2016 *FIRST*<sup>®</sup> Robotics Competition

# Team Updates

# Team Update 21

04/19/2016

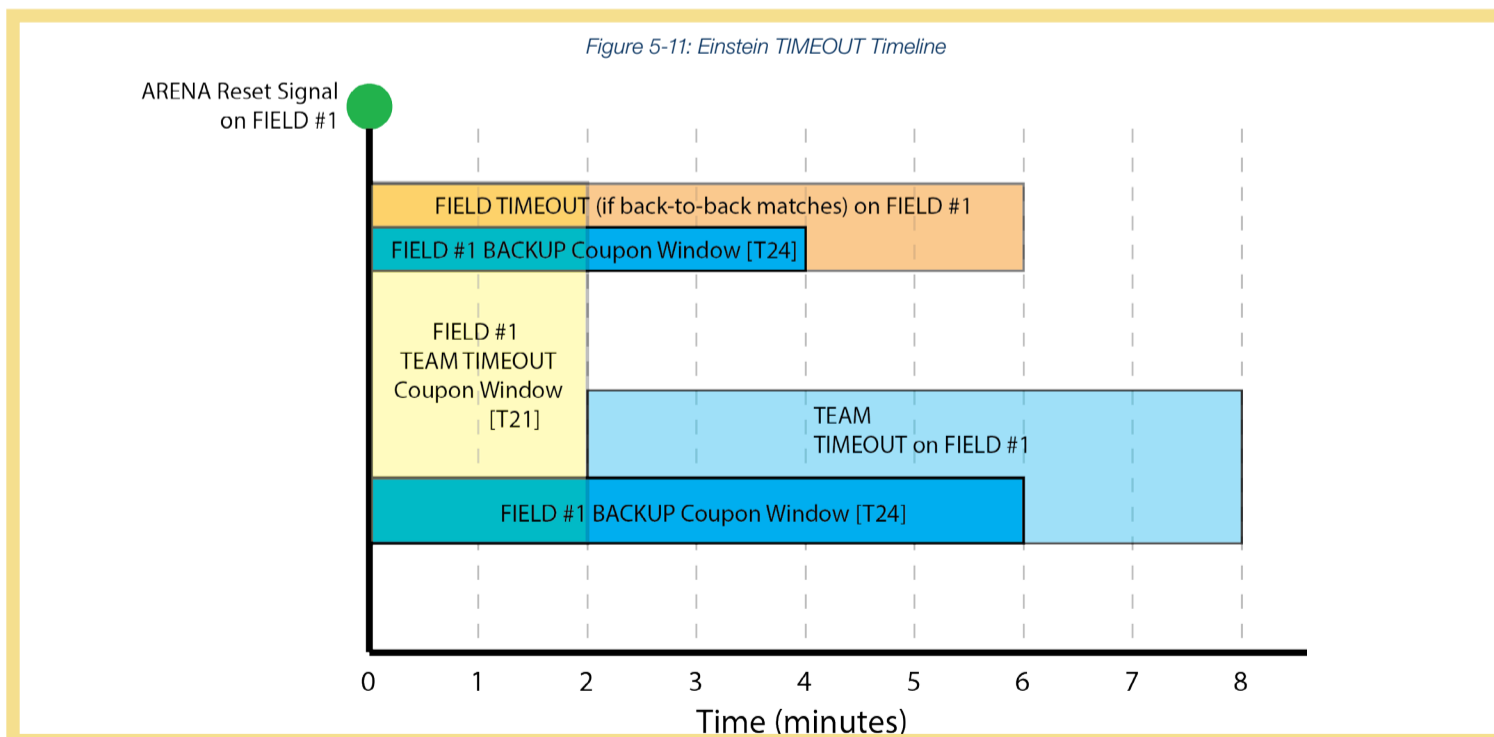
- Figure 5-10 has been edited to change the order of MATCHES so that all odd-numbered Quarterfinal and Semifinal MATCHES are played on the Mass FIELD, and even-numbered MATCHES are played on the Energy FIELD.

Figure 7-1: Defense Selection Timeline for Qualification Matches at the MICMP

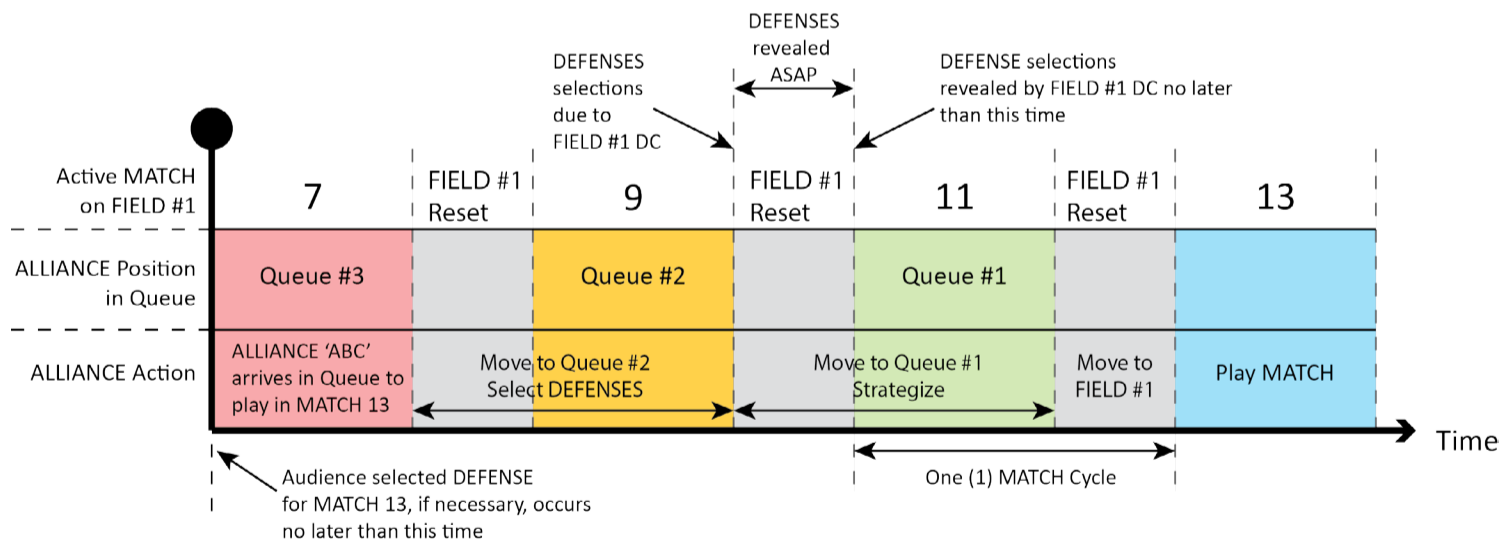
■ The Defense selection for the Michigan District Championship has been adjusted to accommodate the two-Field setup. A graphic showing implementation on Field 1 is illustrated in Figure 7-1, and from this implementation the even-numbered matches on Field 2 can be inferred.

Figure 5-3: MATCH Eligibility Flowchart

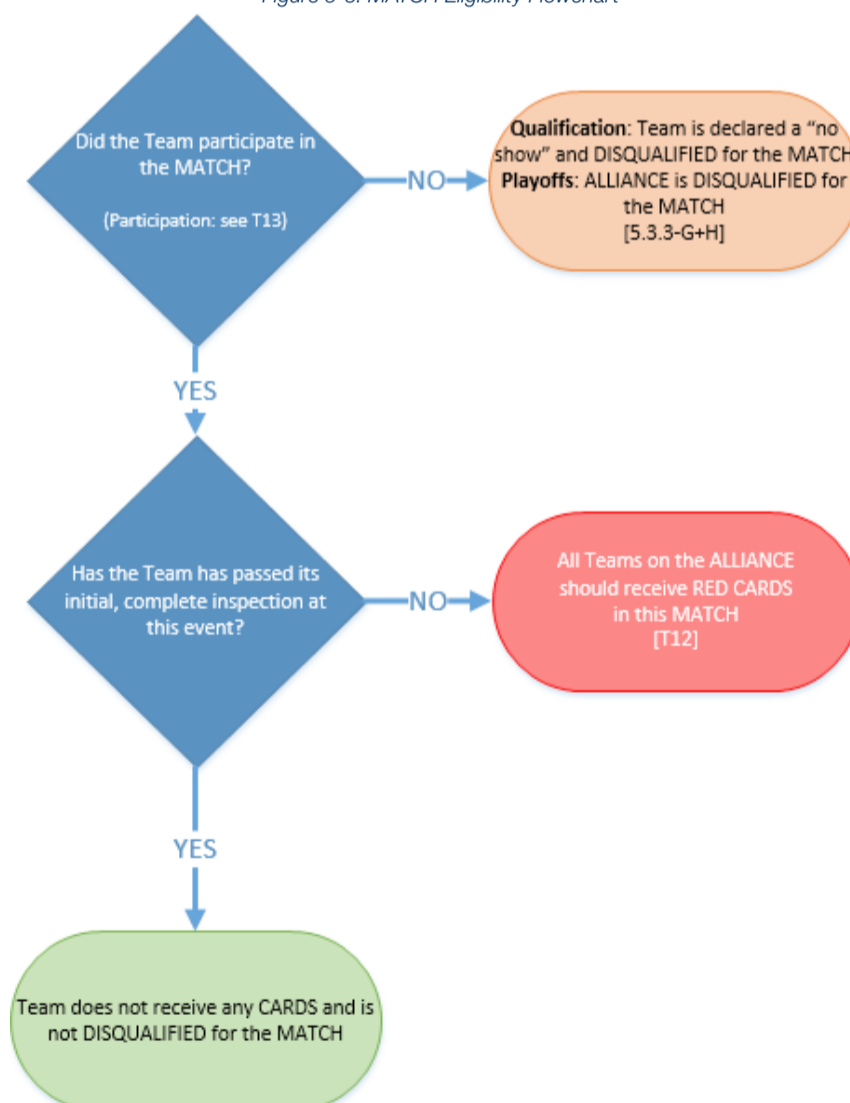
**Also:** Figure 5-3 has been updated to clarify the two possible states for a Team that has not participated in a MATCH.

- References in image updated:

Figure 2-29: High TOWER GOAL Dimensions

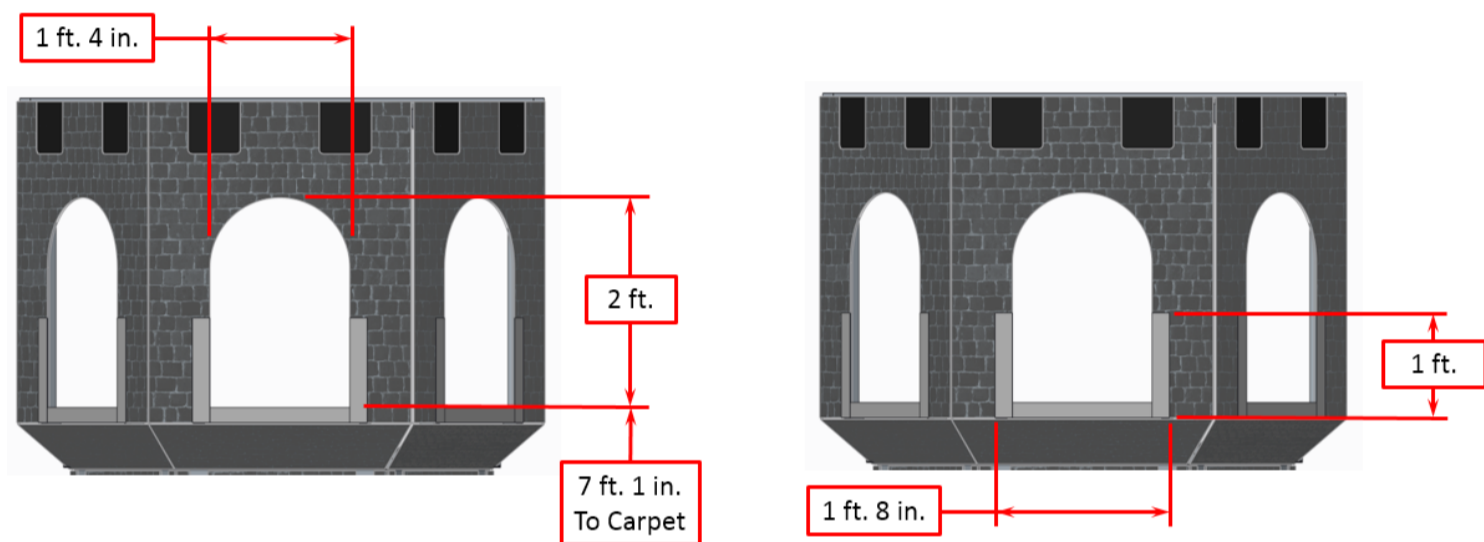
- Each of the high GOALS is marked with ~~three (3)~~ two (2) vertical strips of 2 in. retro-reflective material (3M 8830 Silver Marking Film) and one (1) horizontal strip of 2 in. retro-reflective material (with the unsupported .25 in. folded over the bottom edge of the GOAL opening such that 1.75 in. is visible) to form a u-shaped target.
- Figure 2-29 has been edited to correct the height of the target tape: ~~1 ft. 2 in.~~ 1 ft.

Figure 4-1: BUMPER Corner Examples

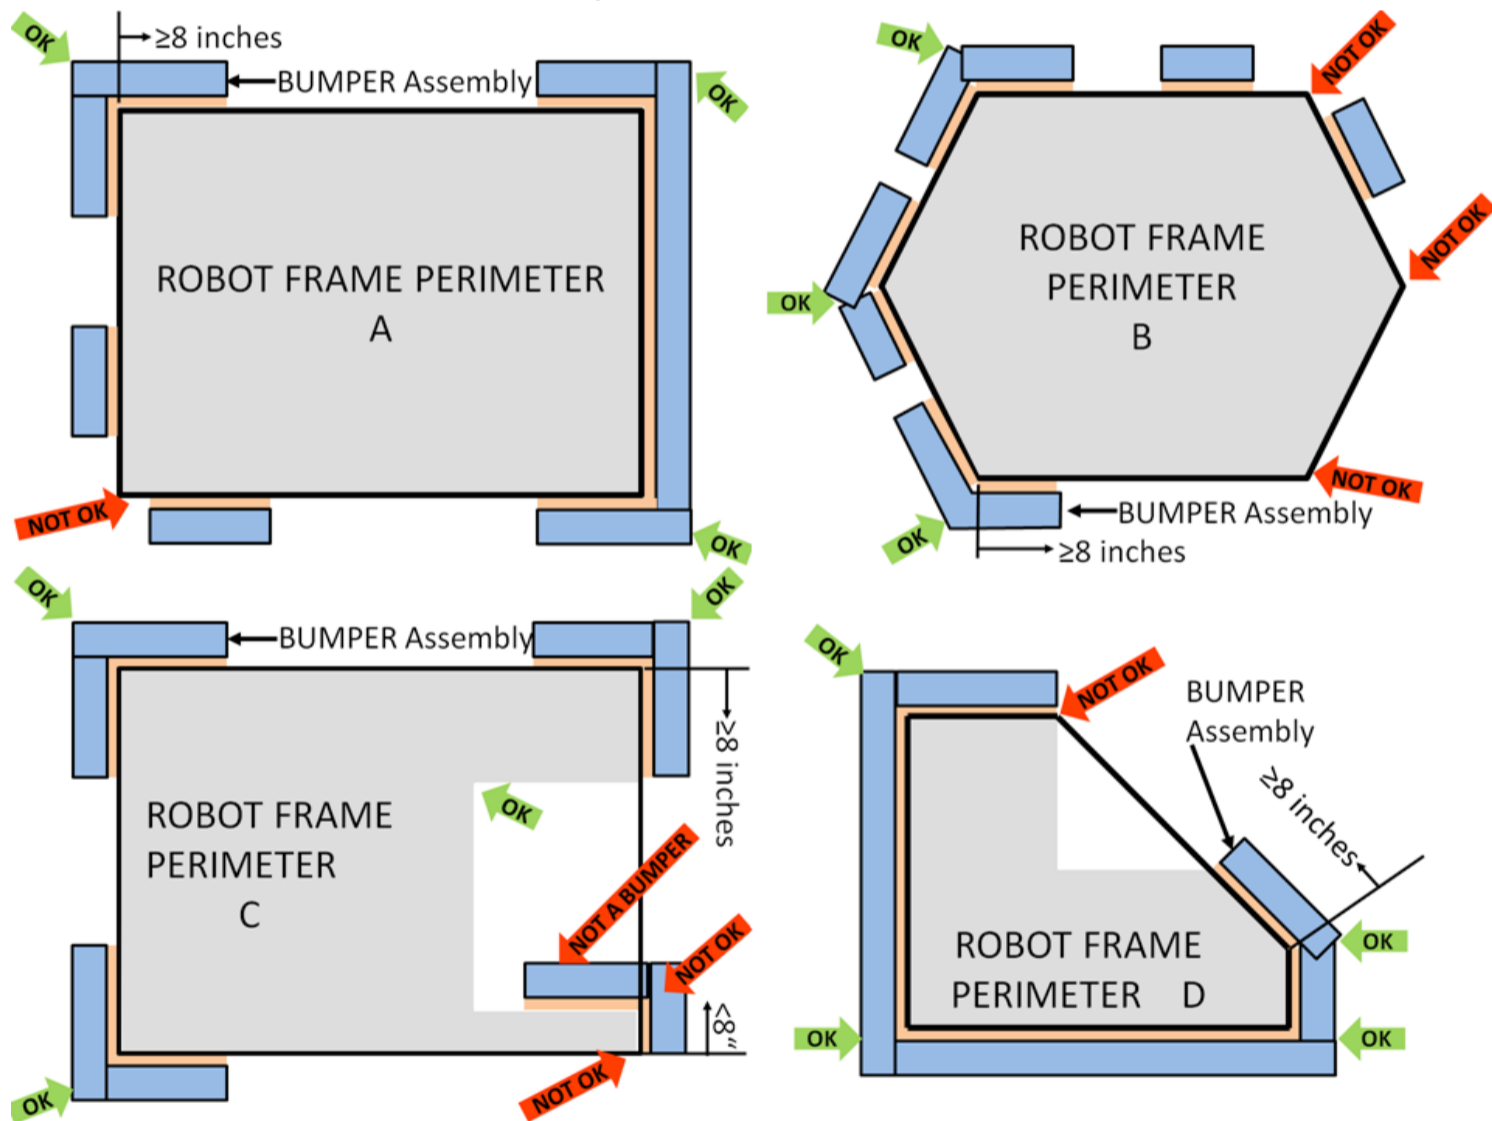
■ Figure 4-3: BUMPER Corner Examples includes an revised lower-left right corner in ROBOT FRAME PERIMETER C.

*Figure 3-2: Examples of G18 compliance and non-compliance.*

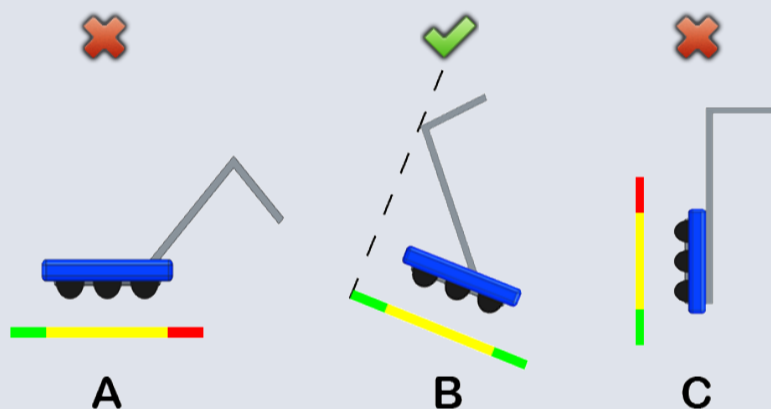
Examples of compliance and non-compliance of G18 are shown in Figure 3-2.

Yellow bars represent the measurement of the FRAME PERIMETER and are drawn in the same orientation of the ROBOT'S FRAME PERIMETER. Green bars represent a measured extension from the FRAME PERIMETER that has not been exceeded. Red bars represent a measured extension from the FRAME PERIMETER that has been exceeded (violating G18). ROBOTS A and C violate G18, whereas ROBOT B does not.
